In re: W264BT, Franklin Township, NJ
BPFT-20160728AFS
Facility ID No. 143711

This refers to the above-captioned minor change application for W264BT.

Overlap attachment:

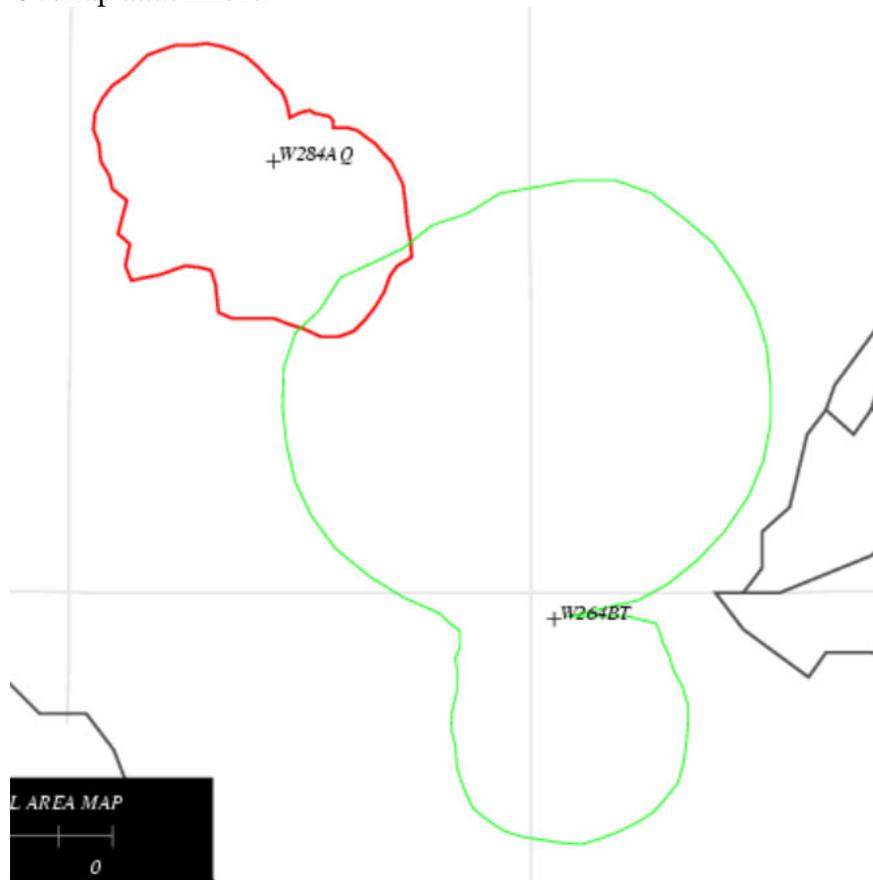
An engineering study reveals the application is in violation of the interference protection requirements of 47 C.F.R. Section 74.1204. Specifically, the proposed 40 dBu interfering contour overlaps the 60 dBu protected contour of the facilities of a co-channel construction permit for a W284AQ, Hackettstown, New Jersey (BPFT-20160630AAP). The application does not recognize this defect. Accordingly, we dismiss the application as unacceptable for filing.

Red contour: W284AQ, BPFT-20160630AAP – 60 dBu protected contour

Green contour: W264BT, BPFT-20160728AFS – 40 dBu interfering contour

In light of the above, application BPFT-20160728AFS is unacceptable for filing pursuant to 47 C.F.R. § 73.3566(a) and IS HEREBY DISMISSED. This action is taken pursuant to 47 C.F.R. § 0.283.
